Ref: 17165-Waitara-BCAReportR3-201217R1

WAITARA PUBLIC SCHOOL

**BUILDING CODE OF AUSTRALIA 2016
FINAL DA STAGE REVIEW**

DECEMBER 2017

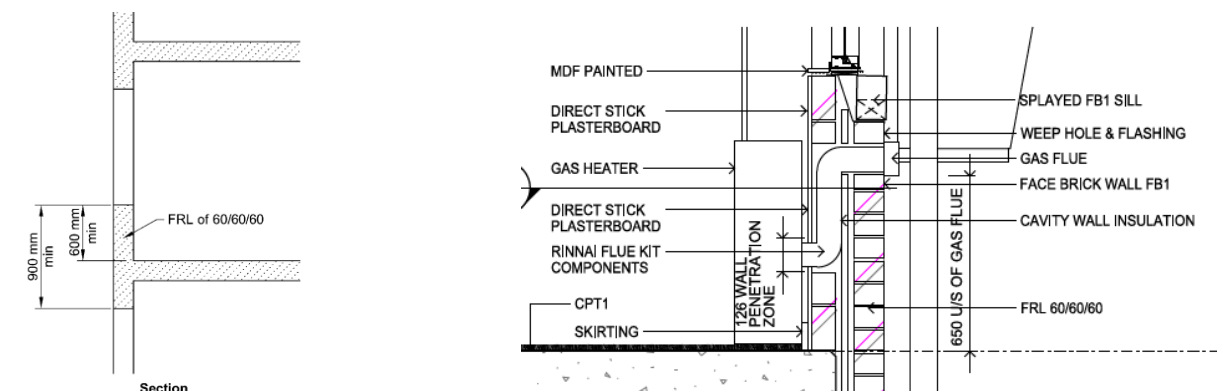
The window and door openings that are directly above one another in the building must be protected by spandrel panels.

Horizontal spandrel panels ie balconies are required to be non combustible eg concrete, have a Fire Resistance Level of at least 60/60/60 and have a minimum depth of 1100mm. Floor wastes should not be provided in the floor of the balcony unless they are PVC and provided with a 60 minute fire collar.

The horizontal spandrel provisions included a requirement for the spandrel panel to extend at least 450mm past the opening, this requires doorway and windows not to be placed within a distance of 450mm from the edge of balconies.

Vertical spandrel panels are required to be non combustible, achieve a Fire Resistance Level of 60/60/60, have an overall height of at least 900mm and a height from the floor level of at least 600mm ie a cill height of at least 600mm. See below.

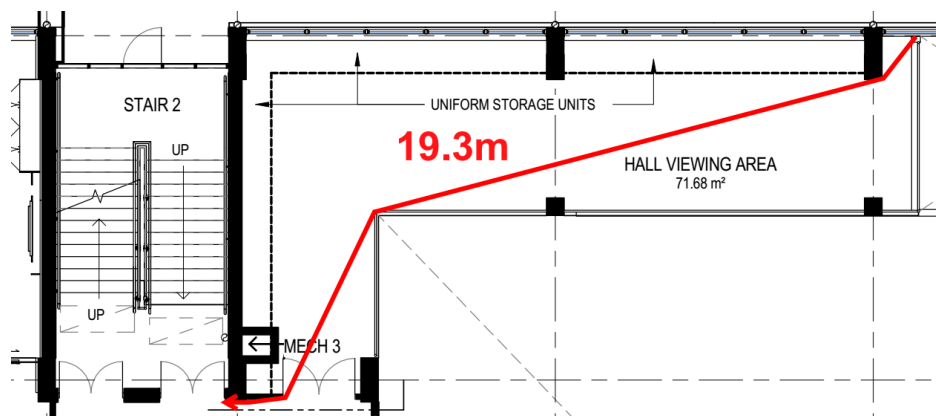
The travel distance from the corner of the homebase 30 on level 4 will have to be reassessed after the furniture plans are provided for review to ensure that the point of choice is within 20m of the starting point. It is expected that egress will be provided from level 3 through the foyer and into the adjoining building.

Please ensure that the hall viewing area on level 2 is not provided with furniture as it may extend the travel distance to the exit to more than the maximum permitted distance of 20m.

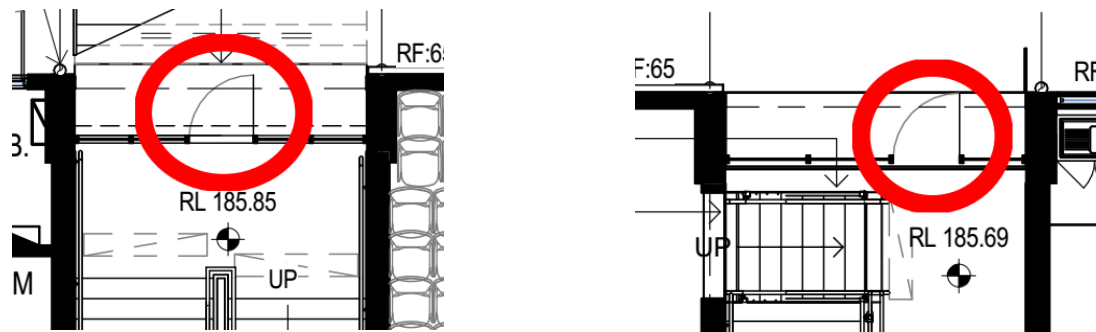
The population of level 3 and 4 is taken to be 400 people on each floor (25 staff and students per classroom x 16 per floor) and therefore the required aggregate exit width on each floor is 4m ie:

- 1.34m of required exit width for each of the stairs. (Each door to be at least 750mm clear.)

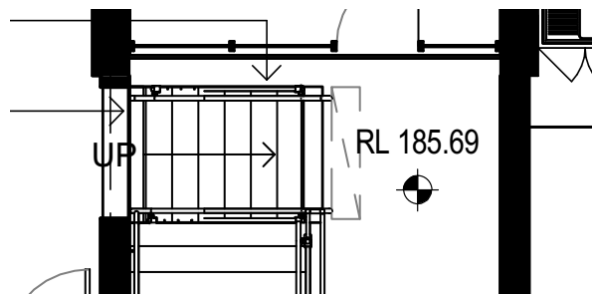
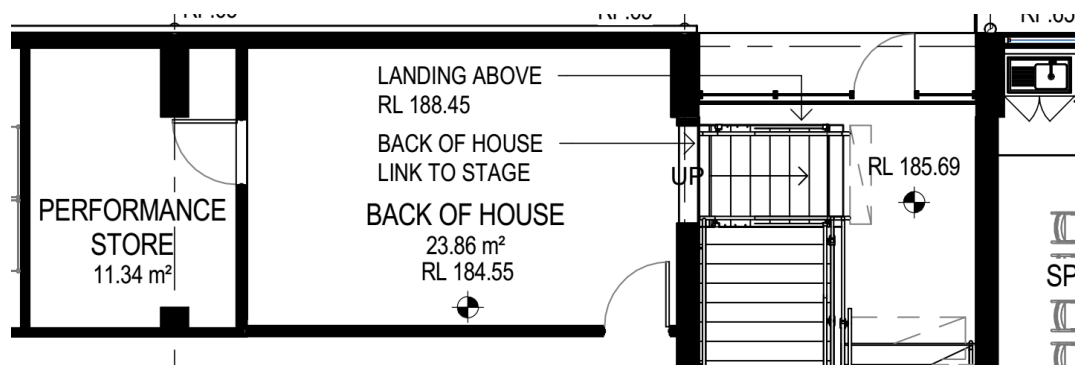
The opening into the level 1 fire stair at grid 8 is not permitted by the BCA and is required to be addressed in a fire engineered performance solution.

In addition, the opening into the fire stair is required to be provided with a fire door. The door that separates the stage from the back of house and the performance store from the back of house should not be used as the fire stair doors as there will likely be too much combustible goods in the back of house room and it should not form part of the fire stair.

Any door provided should incorporate the required 7500mm minimum long top landing to the stair.
